VALLEY OF THE WINDS WIND FARM RESPONSE TO SUBMISSIONS REPORT

Project name **Valley of the Winds wind farm**
Project no. **318001172**
Recipient **ACEN Australia Pty Ltd**
Document type **Response to Submissions report**
Version **V3**
Date **27/10/2023**
Prepared by **Clare Butterfield / Belinda Sinclair**
Checked by **Belinda Sinclair**
Approved by **Belinda Sinclair**
Description **Response to Submissions Report for the Valley of the Winds wind farm project.**

Figure 6-1: Dwellings (7, 8, 9, 10, 11, 12 and 283) assessed on Tongy Station in the EIS

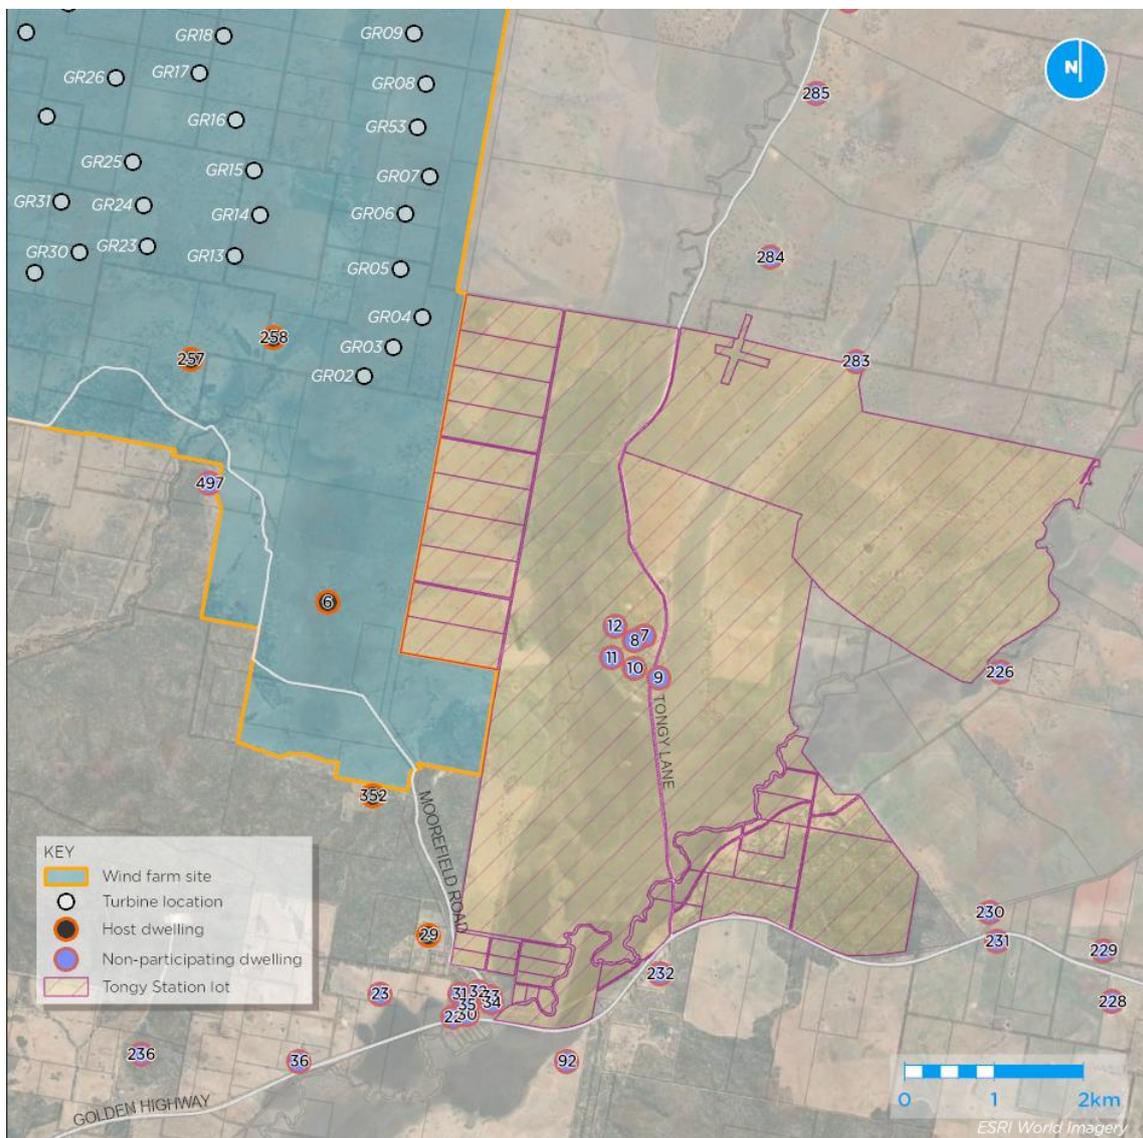
Seven non-associated dwellings were assessed in the EIS on Tongy Station (1340 Tongy Lane COOLAH 2843). These dwellings are shown in **Figure 6-1** below and are Dwellings 7, 8, 9, 10, 11, 12 and 283.

No additional historical dwelling locations were identified during consultation with land holders during preparation of EIS. Since exhibition, ACEN has undertaken a review of historical aerial imagery for Tongy station to attempt to identify the dwelling referred to in the submissions. The review revealed that dwelling 10 and a potential dwelling northwest of dwelling 10 were both burnt down in the 2017 Sir Ivan fire, along with sheds and other ancillary structures on the property. Dwelling 10 and the potential dwelling are shown on **Figure 6-2**. There were no

The area where the potential dwelling previously stood northwest of dwelling 10 was not assessed in the EIS as a dwelling. Although this is the case, Dwelling 10, together with the five other dwellings present on the property were assessed for potential impacts. If a new dwelling is proposed in the same location as the previously burnt down dwelling, the impacts would be expected to be no greater than those concluded for cluster of dwellings assessed for the property. A revised landscape and visual impact assessment (LVIA) and a revised noise and vibration assessment (NVIA) has been prepared as part of the amendment report and reflects the amended turbine layout for the project. Overall, the amended project has seen a reduction in the number of potentially visible turbines from Dwellings 7, 8, 9, 10, 11 and 12 and the noise impacts associated with the amended project are predicted to be well below the criterion for non-associated dwellings (35 dB) at less than 30 dB.
